CITY OF ROCKVILLE HISTORIC DISTRICT COMMISSION STAFF REPORT

MAY 10, 2000 MEETING NO: 5-2000

APPLICATION: HDC00-0165

Address: 411 West Montgomery Avenue

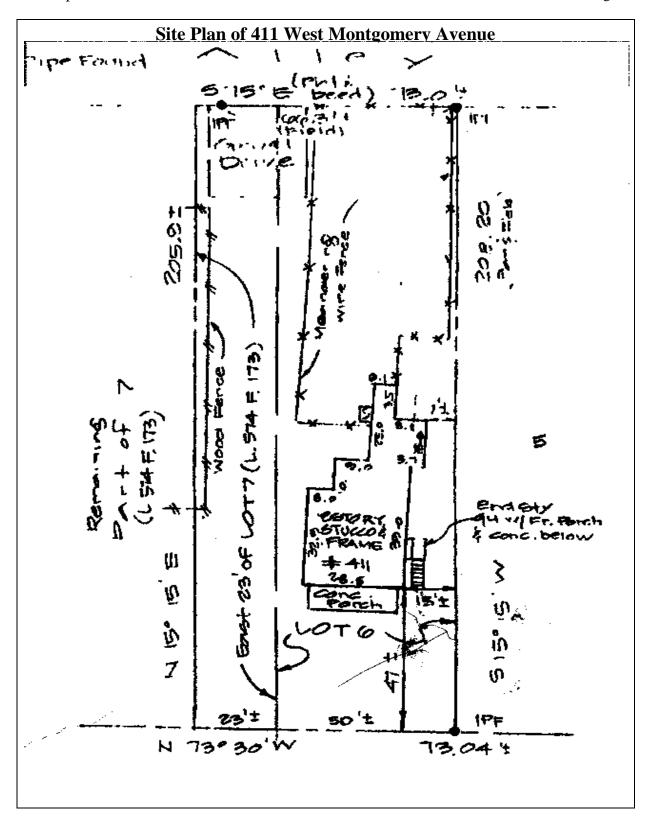
Staff recommends approval to HDC00-0165 with HDC concurrance. Staff has examined the proposed ventilator specifications and noted that they are very obvious. However, this may have been intentionally so to illustrate the product. Staff has determined that both the fan and the soffit vents will have marginal impact from the public way and will produce a more comfortable and efficient house.

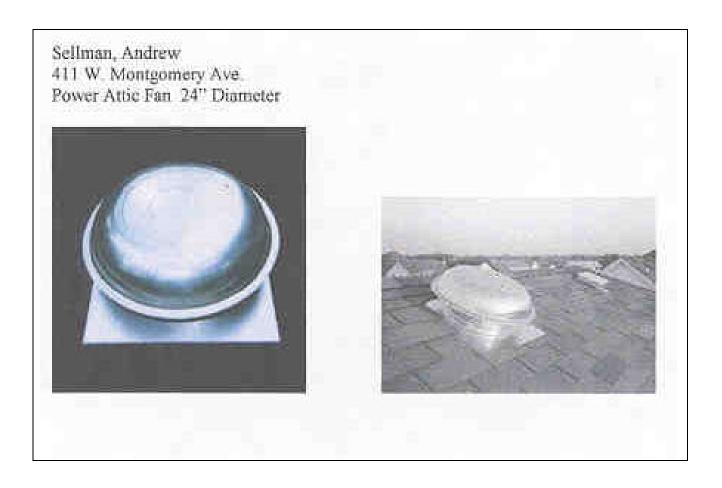
The applicant has proposed paintable wood soffit vents and has located them only on the side elevations. The vents will be painted the same color as the surrounding soffits, which will

somewhat mitigate their impact. Staff feels that the applicant has found materials that meets the need to ventilate the attic for comfort and protection against deterioration, yet is sympathetic to the character of the house and to the public perception of it. The fan does not contribute to the design and character of the house but again has been placed to be the least visible to the public and will have no impact on the streetscape.
